**Application by
Fingal County Council
for Waste Licence Application W0231-01
for Fingal Landfill, Co. Dublin**

***Replies to Request
for further information in accordance with
Article 14(2)(b)(ii) of the Waste
Management Regulations***

December 2006

Figure **21.6**

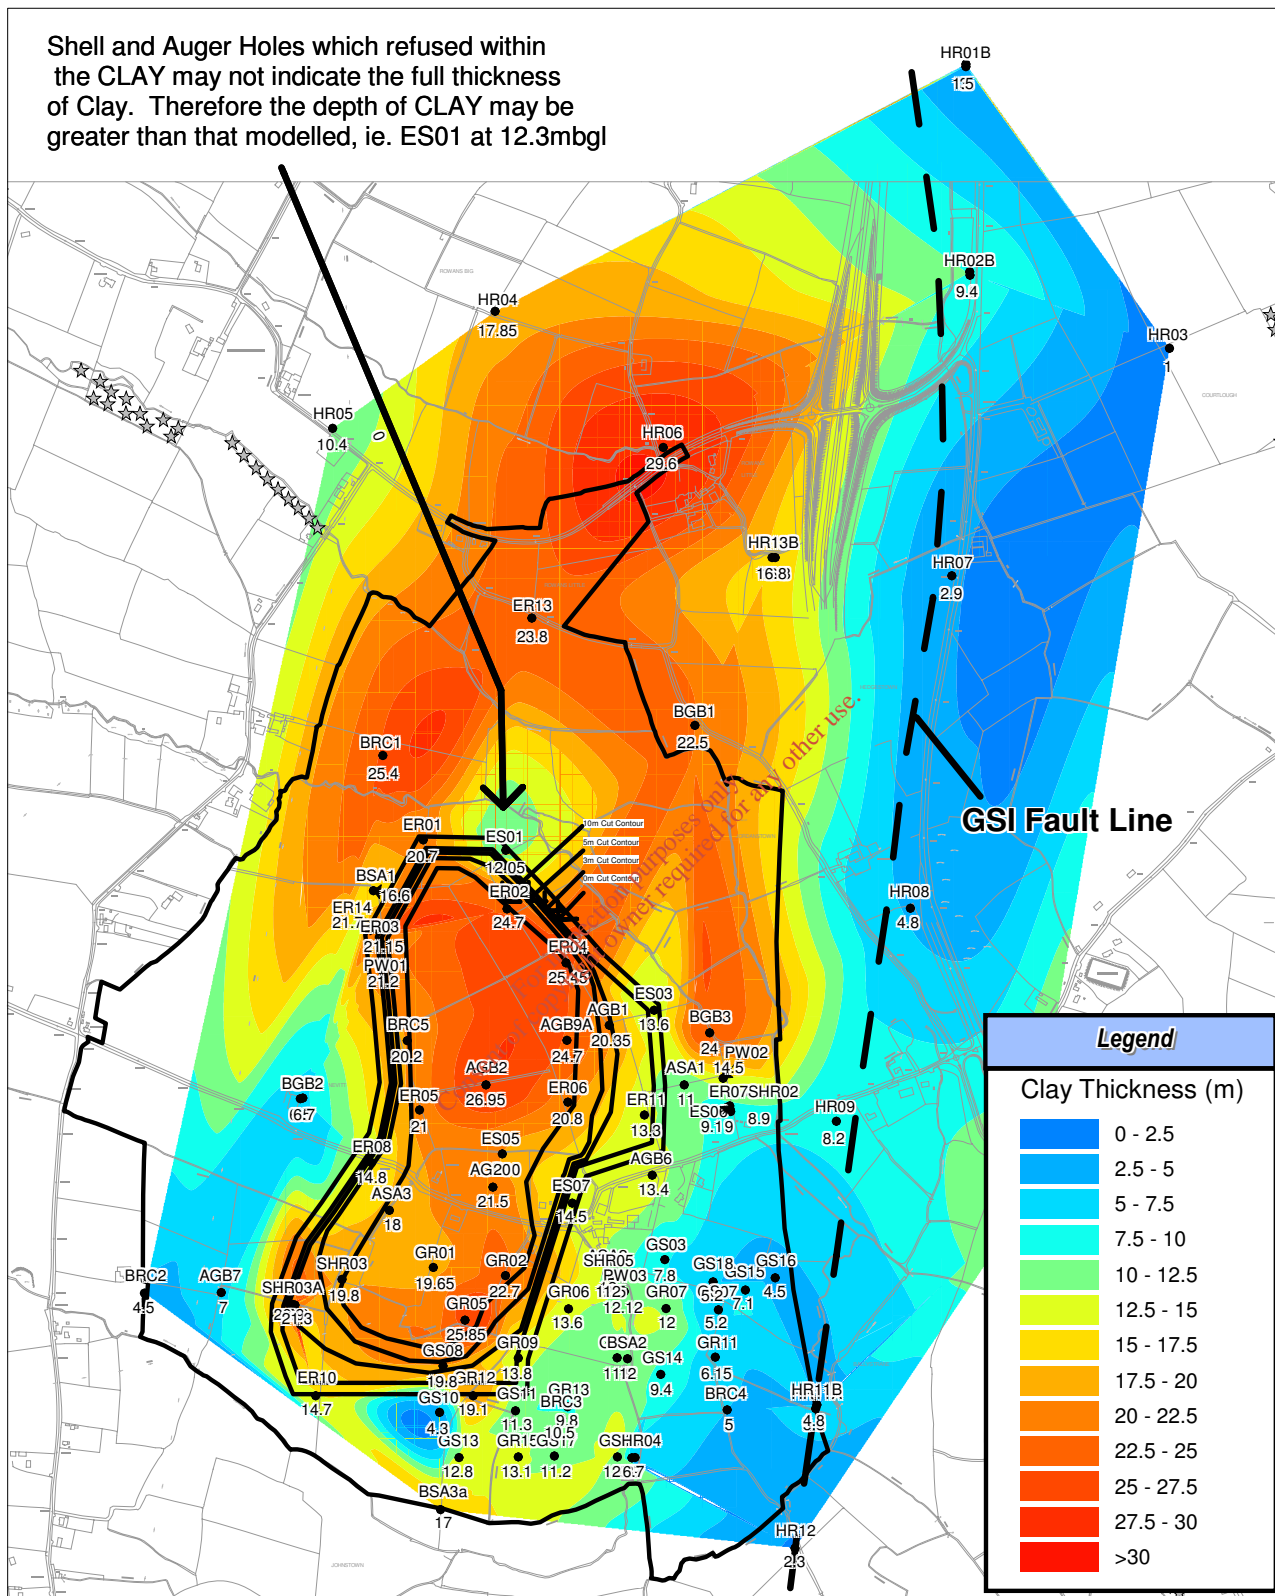
Provides thickness contours (plan view) of the clay overburden for the current site conditions and following development to formation level.

A drawing of clay thicknesses is provided as **Figure 21.6** at a later stage within this report. A commitment is given within the EIS, section 2.2.6, to maintain 10m depth of low permeability clay beneath the footprint of the landfill. This is to ensure that the site maintains the lowest risk response of 'R1' in the DoEHLG / EPA / GSI Response Matrix for landfills. This will be achieved and once the detailed design is complete, the floor layout of the cells will be forwarded to the EPA under the Specified Engineering Works Procedure which will demonstrate that 10m of clay cover remaining in-situ following the development of the cells to formation level.

A bedrock contour map depicting the elevation of the bedrock surface is given on **Figure 21.5**. In addition, the thickness of clay deposits underlying the site area has been provided in **Figure 21.6**. The clay deposits offer protection to the underlying groundwater quality.
